PROJECT NUMBER / TITLE: FDP-20-01 New Life Community Church

Type of Request: Final Development Plan
Date Received: January 10, 2020

The applicant is requesting approval of a final development plan for a church.

SITE DIMENSION PLAN NEW LIFE COMMUNITY CHURCH GARDNER, KANSAS FINAL DEVELOPMENT PLANS

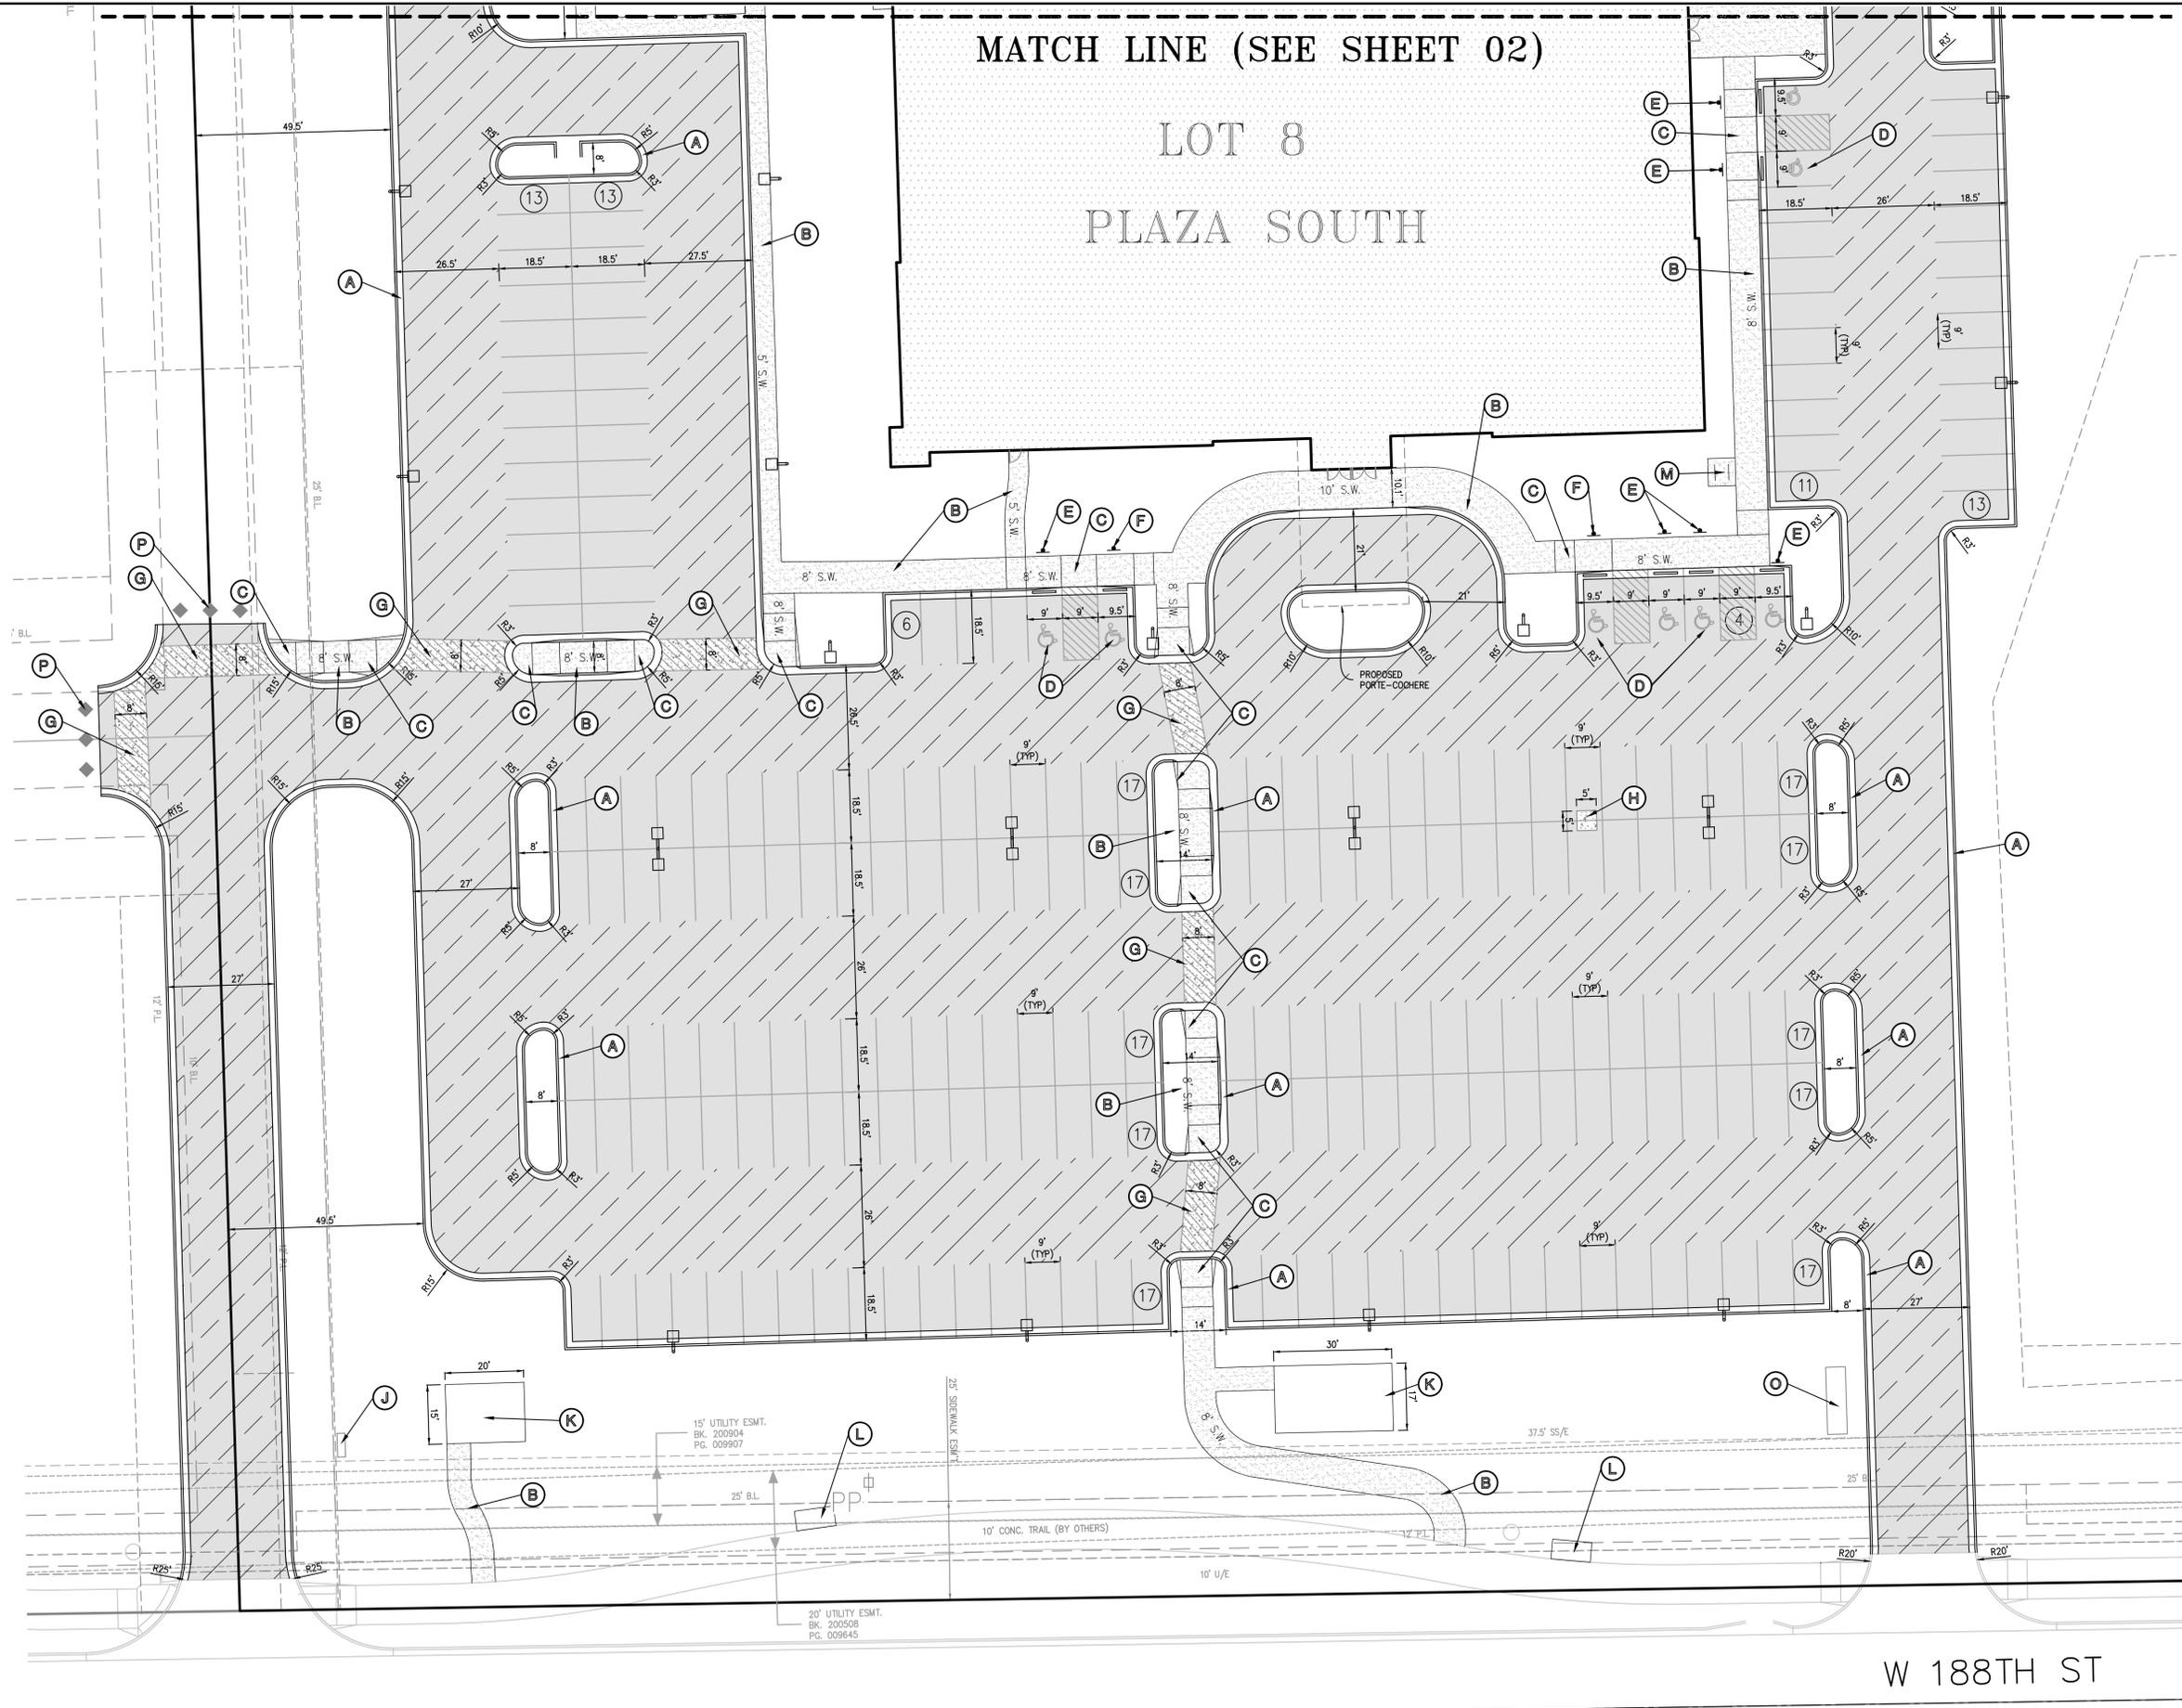
Proposed: 31' access for east drive onto 188th Street.

Staff Comment: The access width limits for Terrace Frontage would possibly cause congestion at this access point with the number of vehicles that will be arriving and leaving this site at the same time. The large flared entrance also allows for larger trucks to be able to make deliveries without driving over the curb. Staff is supportive of this deviation.

1 OVERALL SITE LANDSCAPE PLAN

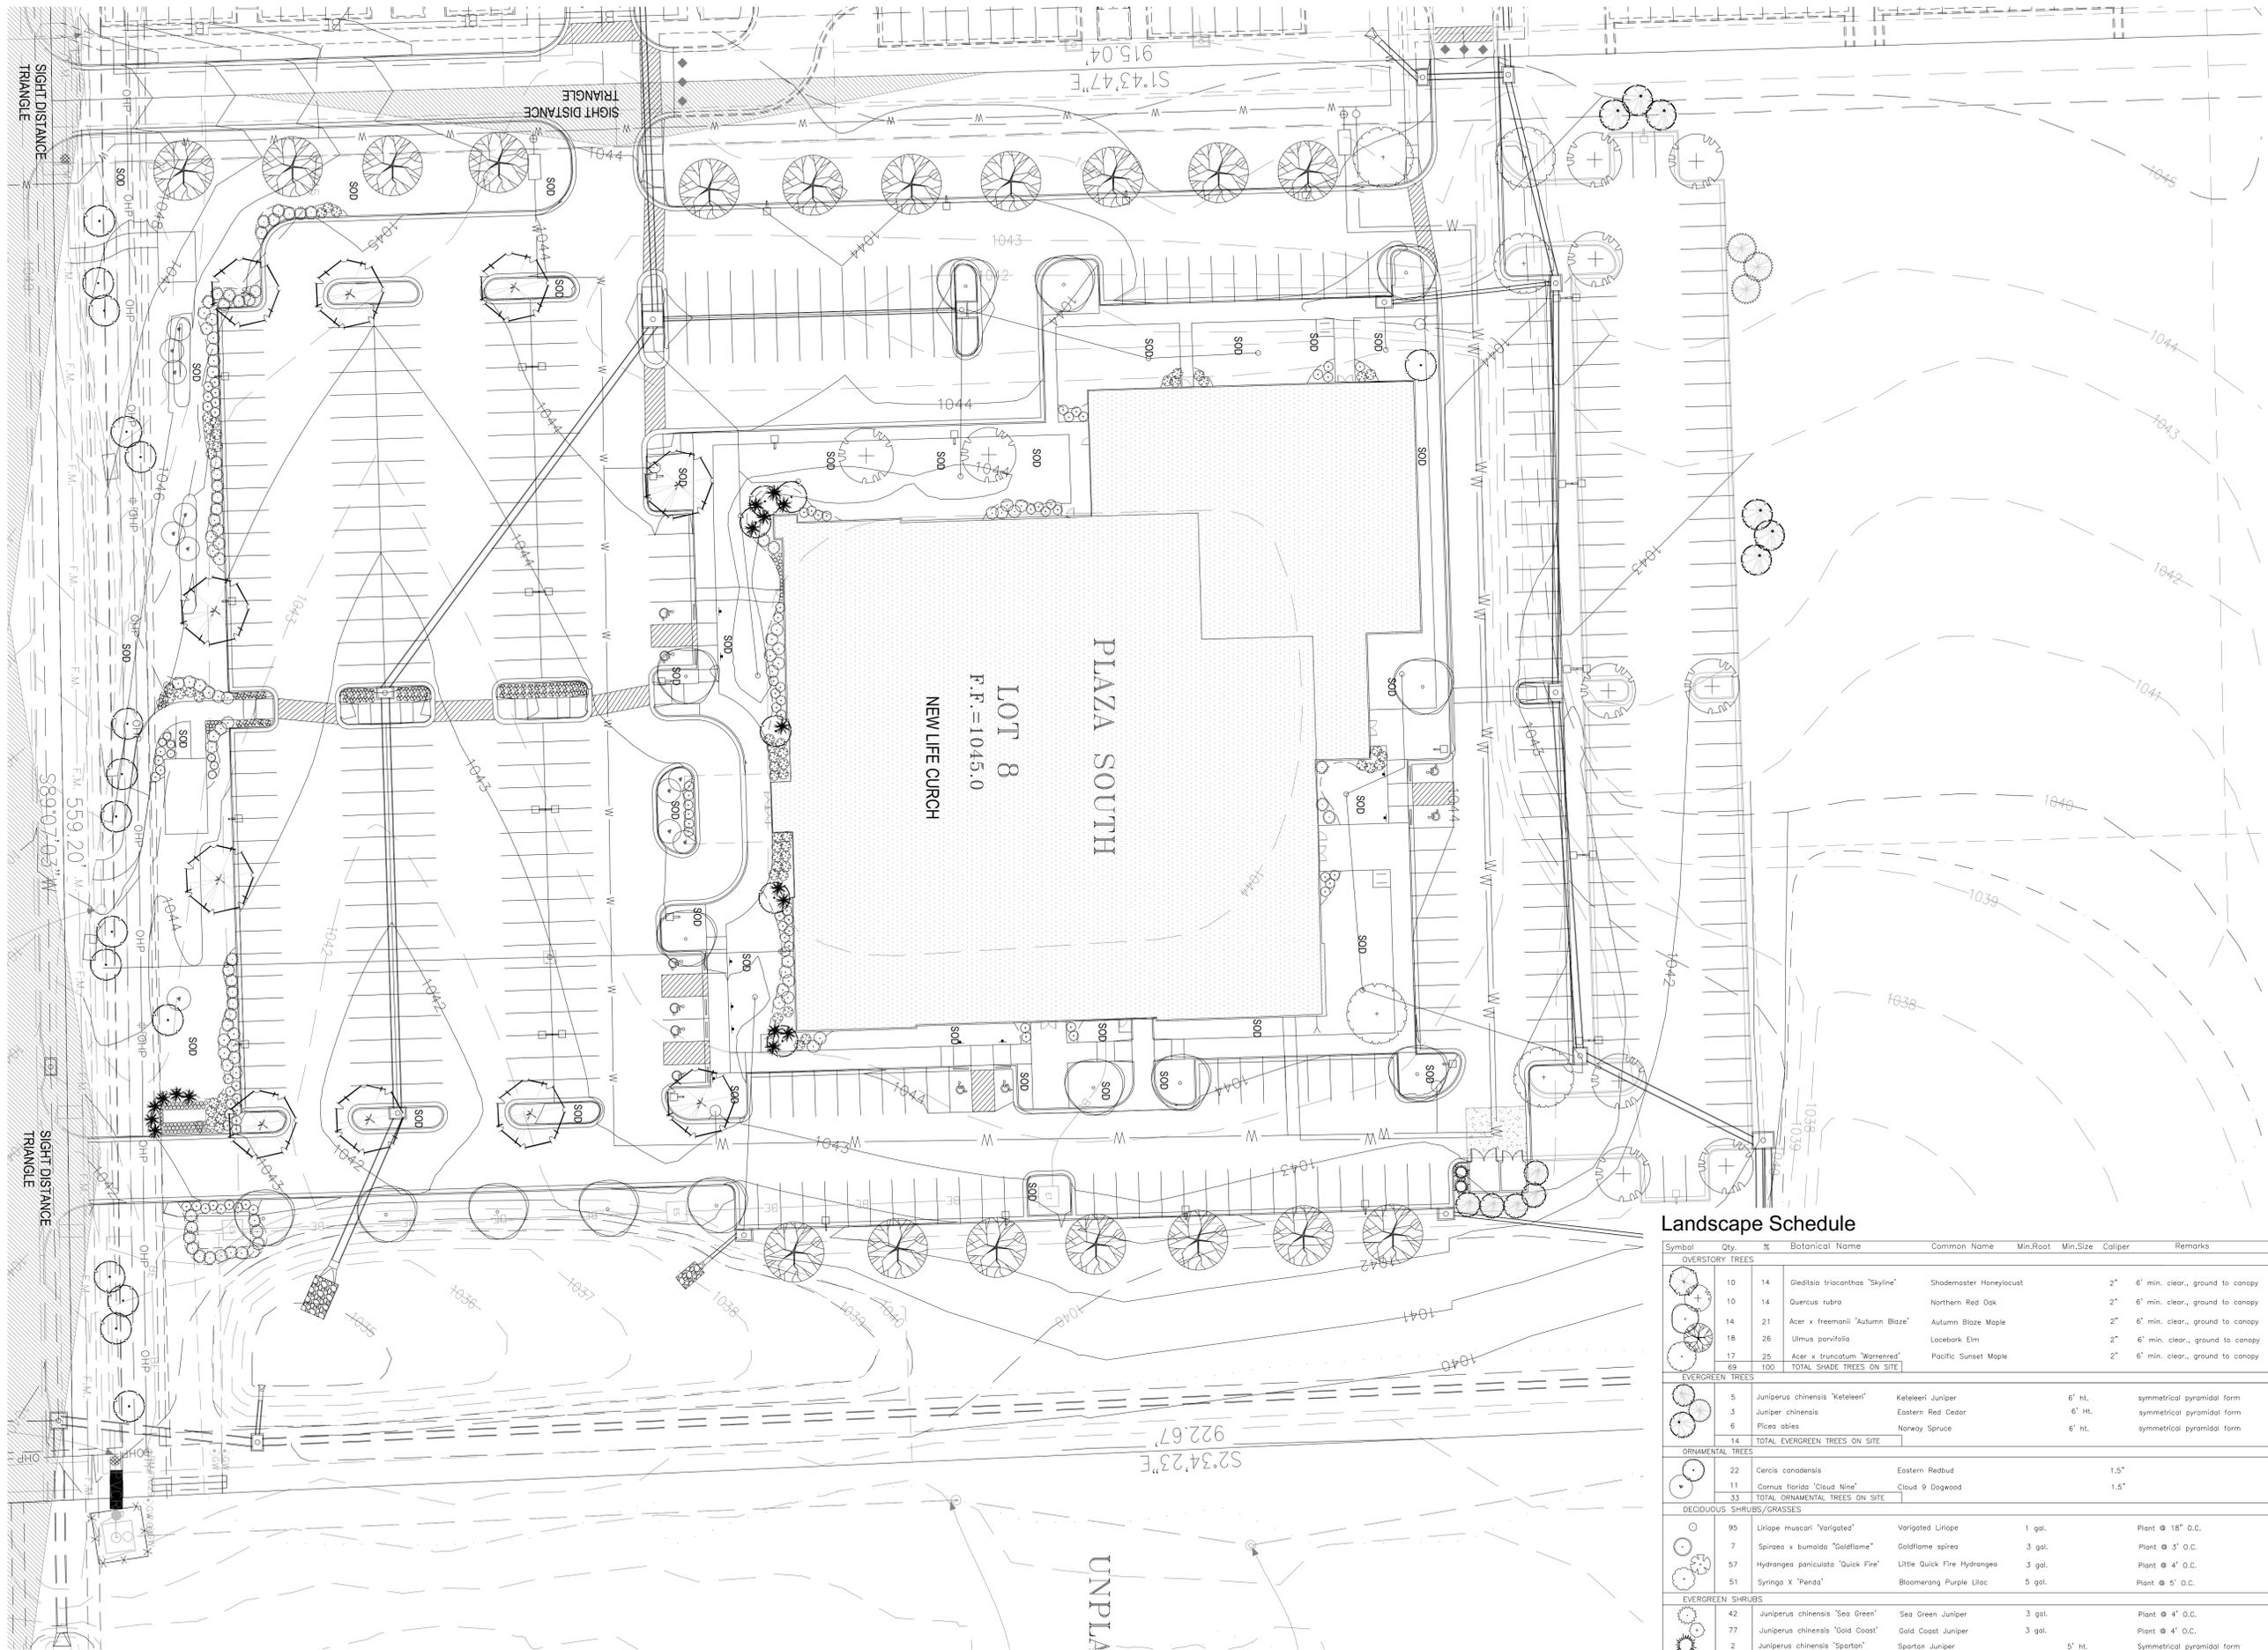
- *Substitute deciduous trees for the northern-most trees adjacent to the deferred parking, and space along the perimeter of the parking lot.*
 - *Provide a direct, continuous sidewalk from the Church to the deferred parking lot.*
2. In making a determination of compliance, or for final development plans accompanying any discretionary review or administrative relief, the review body shall consider whether:
- a. The site is capable of accommodating the buildings, proposed use, access and other site design elements required by the Code and will not negatively impact the function and design of rights-of-way or adjacent property.

Staff Comment: *A few trees will need to be changed along the north parking lot, other than this condition, no additional site specific conditions are necessary.*

5. Substitute deciduous trees for the northern-most trees adjacent to the deferred parking, and space along the perimeter of the parking lot.
6. Provide a direct, continuous sidewalk/crosswalk from the Church to the deferred parking lot.
